FAIRFAX COUNTY

STAFF REPORT

APPLICATION SE 00-H-028

PROPOSAL: Approval of a Special Exception for a church with a nursery school, child care center, and private school of general education with an enrollment of 100 or more students daily.

JOHN W. HARRIS, ARCHITECT
 10000
 EDUCATION BUILDING
 SPECIAL EXCEPTION
 PLAT
 C-2

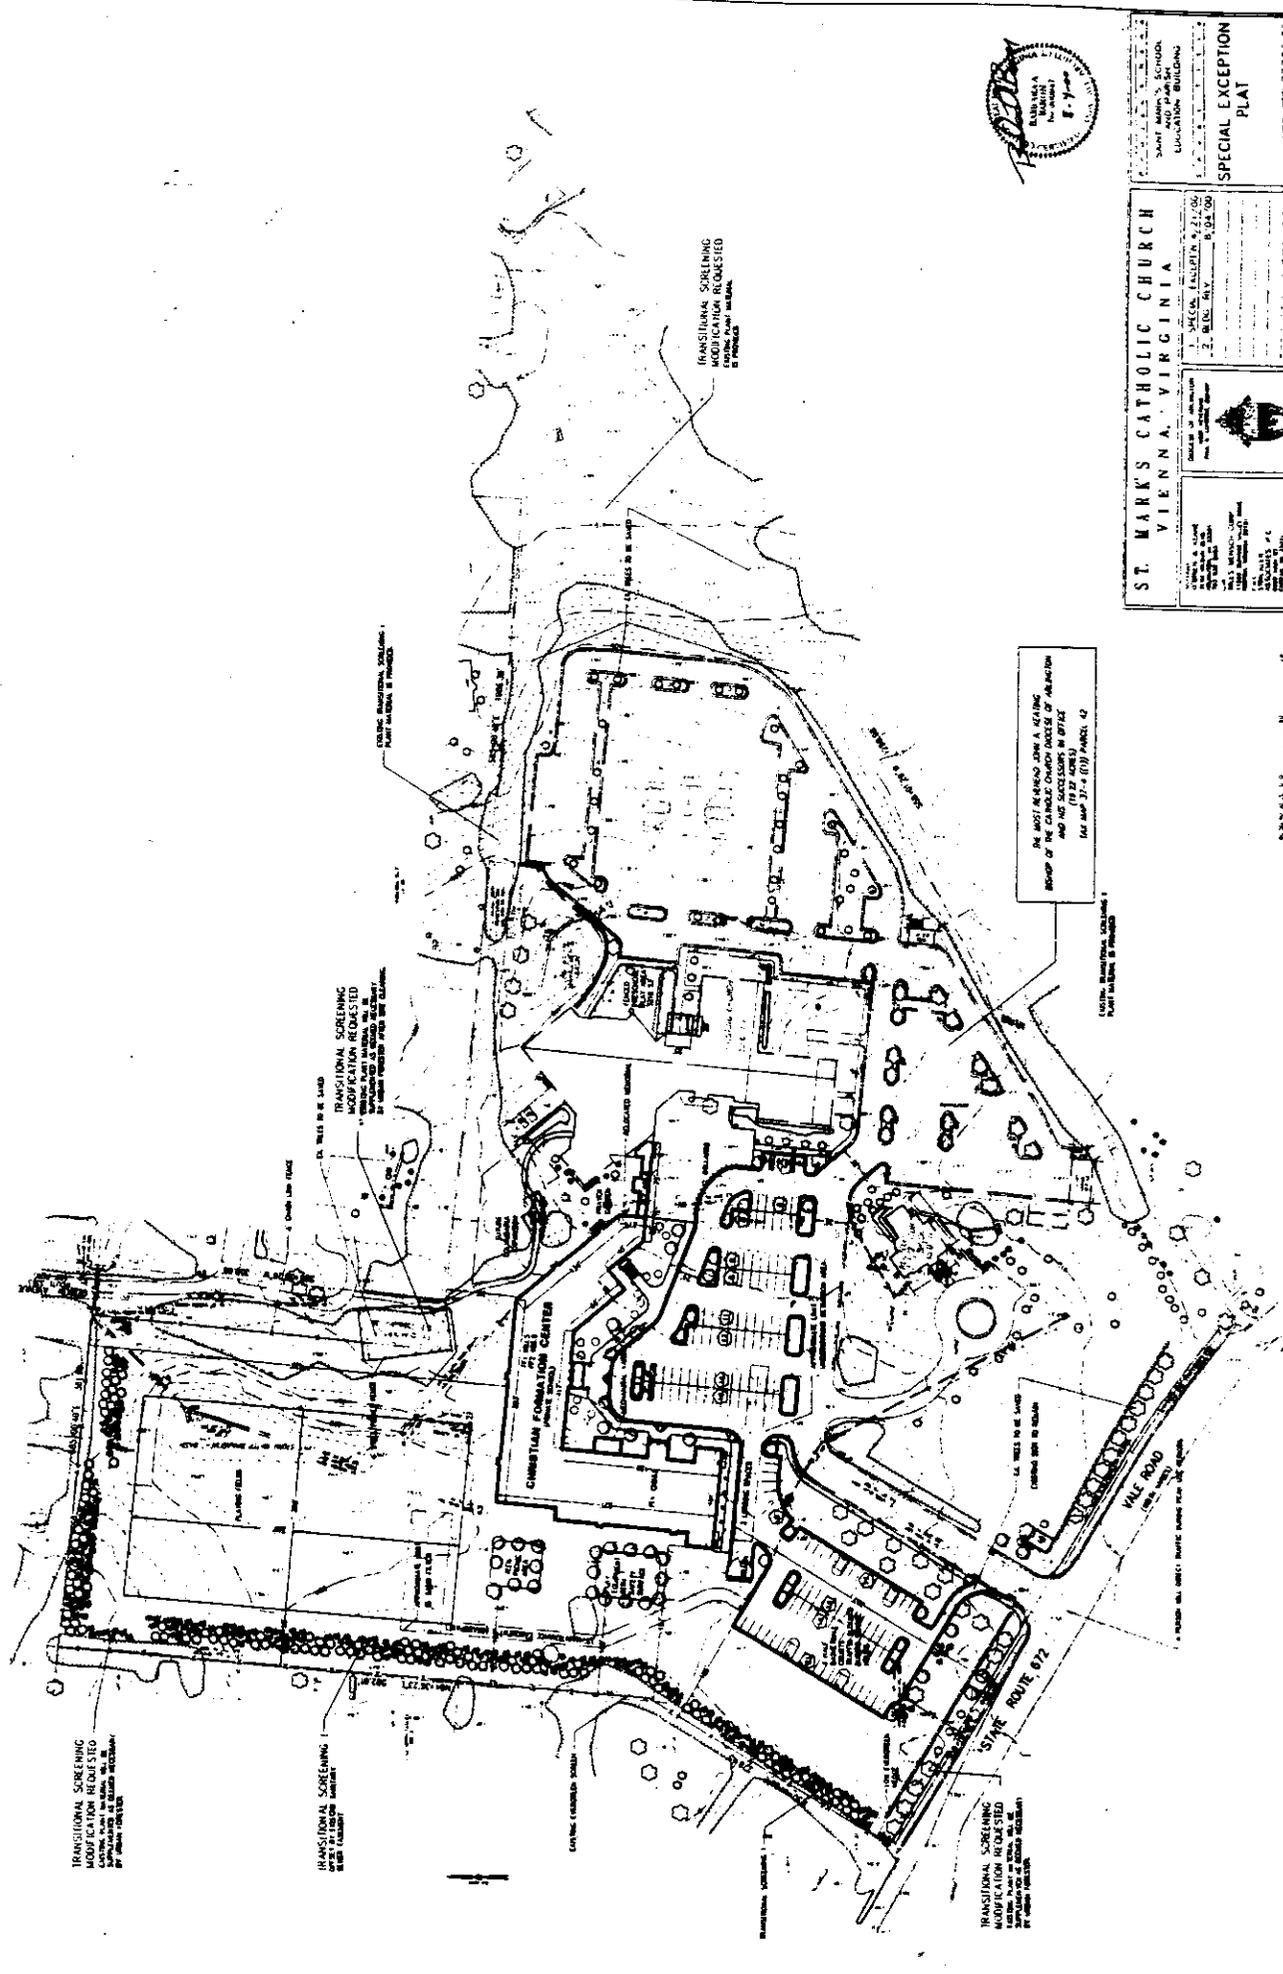
The SE plat initially depicted an elongated wing to be attached to the existing church which extended to approximately 60 feet from the western property boundary. The proposed new addition was not compact in design like the existing church, which is designed as a modified semi-circular building centrally located on the site. The applicant was encouraged to consider a design modification which would shift the bulk of the new building toward the center of the site and incorporate a building design that is more closely related and integrated with the existing church in terms of style, size and mass. The recommended design modifications would minimize clearing and grading on the site by utilizing some of the existing paved area for the new addition and minimizing visual and noise impacts on the adjacent residential neighborhood.

The proposed school structure was redesigned to reduce the proximity to and impact upon the adjacent residential properties to the west. The revised layout is more compact in design, and moves some of the mass further inward on the site. The school is now an "L" shaped structure, and is 157 feet from the western property line at its closest point. The proposed location of the building does incorporate the use of some existing pavement. The two-story school will be approximately 23.5 feet high. The proposed façade will be similar in character to the existing church, and the applicant has stated that the exterior building materials will consist of primarily brick, with a sloped shingled roof. Building elevation drawings were provided by the applicant, and are included at the end of this report. Further, development conditions are proposed which would require the building to be constructed of primarily brick with a sloped shingled roof, as stated, and for the façade to be in substantial conformance with the attached elevation rendering. Therefore, staff believes this issue has been satisfactorily addressed.

The southwestern boundary, along Vale Road, will have ornamental landscape in lieu of the required buffer. Due to the location of the church and the proposed school which is set back significantly from the road, staff believes this is an acceptable design alternative. Therefore, staff supports this modification request.

18. A landscape plan shall be submitted as part of the first submission of site plan(s) and shall be reviewed and approved by the Urban Forestry Branch. The plan shall provide for landscaping consistent in quality and quantity with that shown on Sheet C-2 of the SE Plat; with the addition of the following:

- Additional trees and plant material shall be added to the buffer shown on the SE Plat at the western, northern and northeastern peripheries to further mitigate the impact of the playing fields on the adjacent residential properties. Existing vegetation shall be preserved and supplemented along all boundaries except along Vale Road to meet the intent of Transitional Screening Type 1. The number, quality and species required shall be determined by the Urban Forestry Branch. The existing vegetation in these areas shall be preserved to the maximum extent possible. The limits of clearing and grading shall not extend into the required minimum transitional screening yard, except in the areas along the storm sewer easement on the western boundary which contain no existing vegetation and which requires further grading to resolve an existing drainage problem.

ST. MAR'S CATHOLIC CHURCH
 VIENNA, VIRGINIA

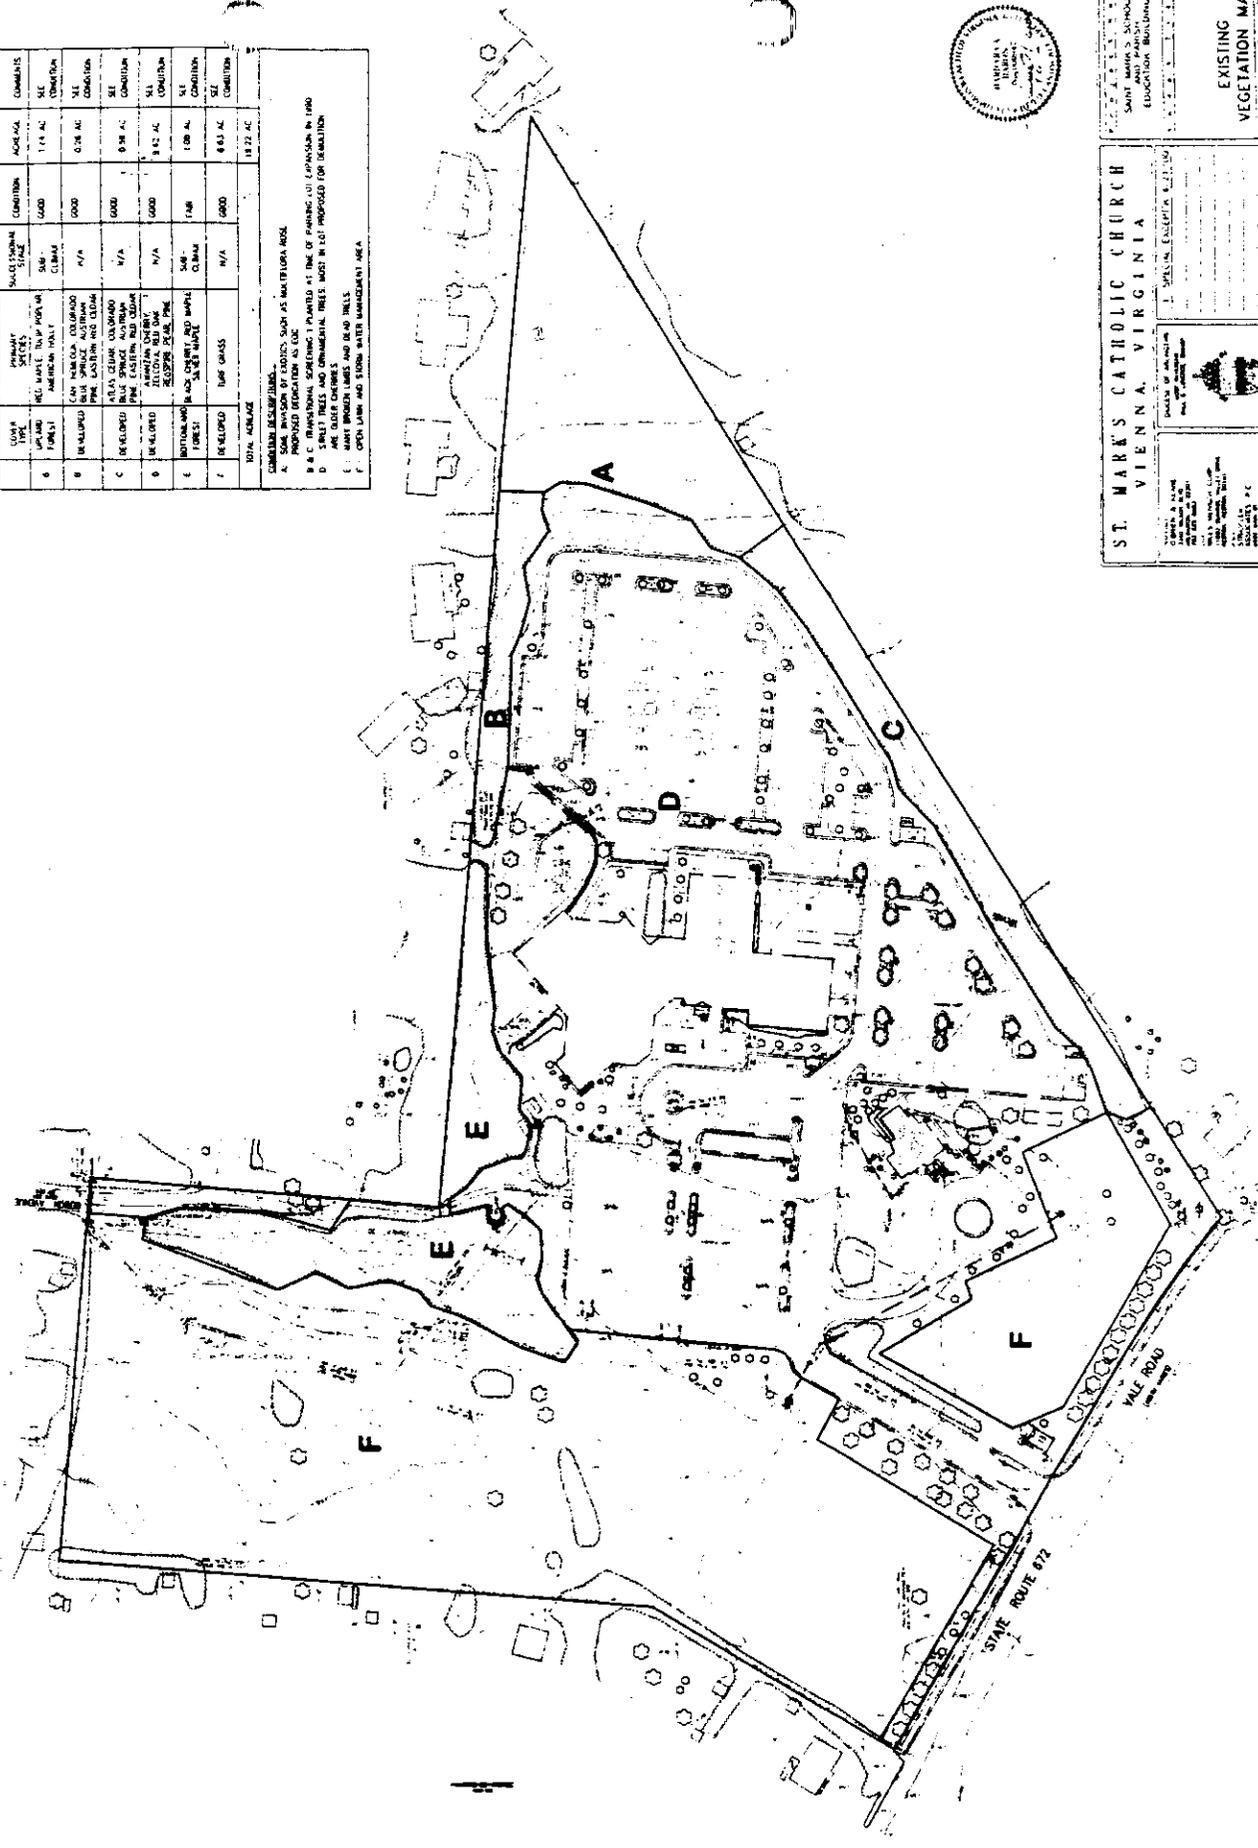
The development proposal includes an existing vegetation survey. However, the plan indicates that the school structure will be partially positioned in the bottomland forest area, which is identified on the EVM as E. This existing natural feature enhances water quality and presently serves as a natural detention area for stormwater runoff from the existing church facilities. It is recommended that the applicant attempt to preserve more of the bottomland forest north of the proposed school.

The development proposal includes an existing vegetation survey. However, the revised plan indicates that the Christian Formation Center will be partially positioned in the bottomland forest area, which is identified on the EVM as E. This existing natural feature enhances water quality and presently serves as a natural detention area for stormwater runoff from the existing church facilities.

The area north of the proposed school, which is currently used for stormwater detention, will be filled in and used for playing fields. The new stormwater management system will consist of sand filters and underground detention. The majority of the existing vegetation to be preserved is around the periphery in that area. The applicant has stated that they are willing to preserve the existing vegetation to the maximum extent possible. In addition, a development condition is proposed which states that a landscaping plan must be submitted for approval by the urban forester, that the existing vegetation shall be preserved where possible, particularly along the periphery, that the existing vegetation on the periphery will be supplemented for further screening, and that the limits of clearing and grading shall not extend into the required buffer area within 25 feet of the property line, except where additional corrective grading is needed along the existing storm sewer easement on the western boundary (not in the area of existing vegetation). In addition, a development condition is also proposed which states that the existing vegetation along the northeastern and southeastern peripheries will be preserved. Therefore, this issue has been resolved.

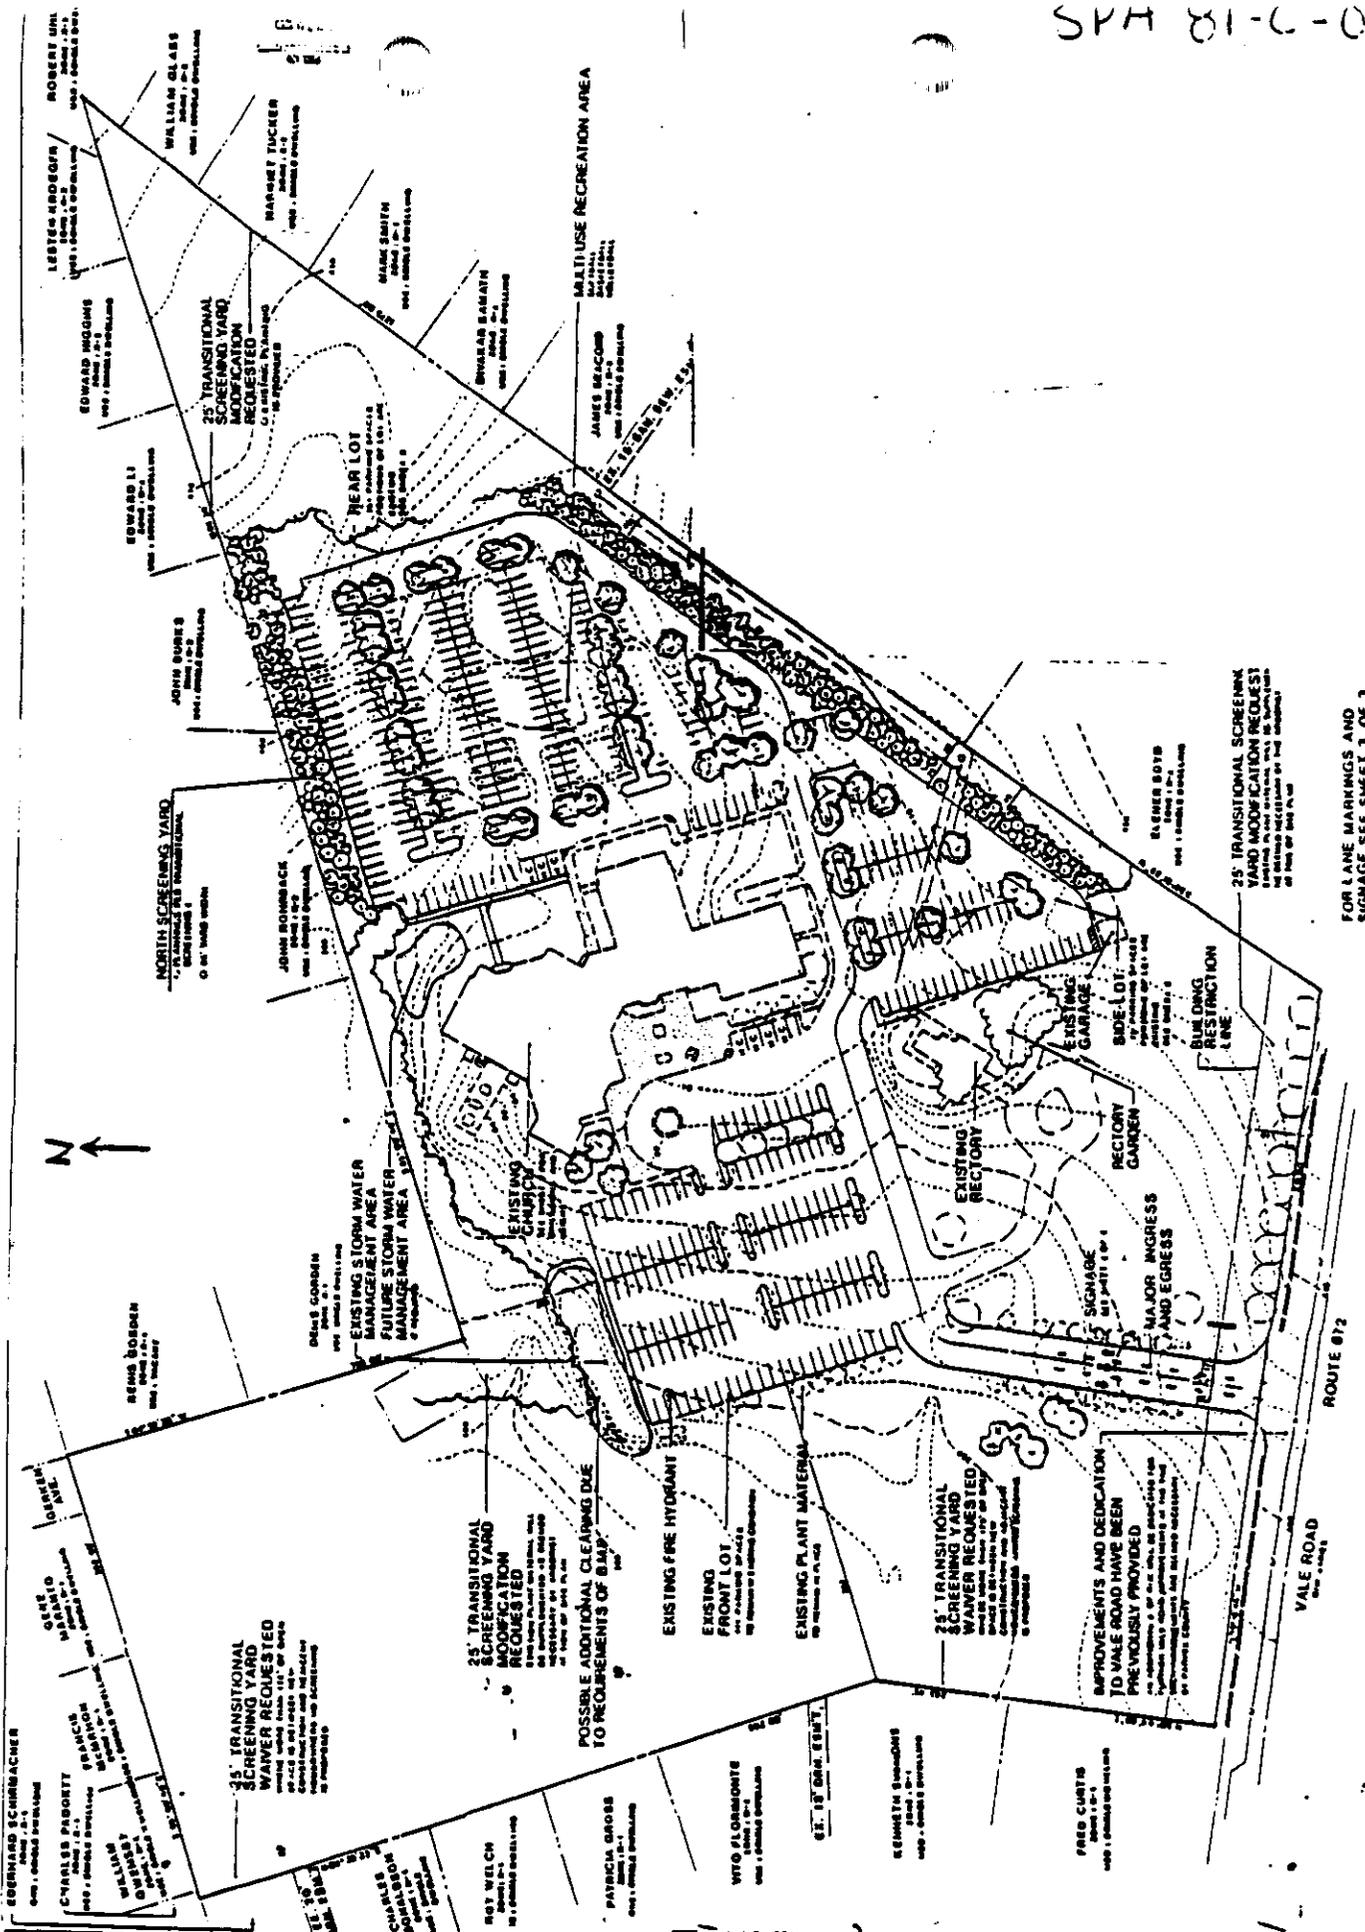
25' TRANSITIONAL SCREENING YARD MODIFICATION REQUESTED

25' TRANSITIONAL SCREENING YARD MODIFICATION REQUESTED

The barrier requirement shall be waived along all lot lines. All new plantings required under this condition shall be subject to review and approval of the County Arborist with respect to size, type, location and quantity.
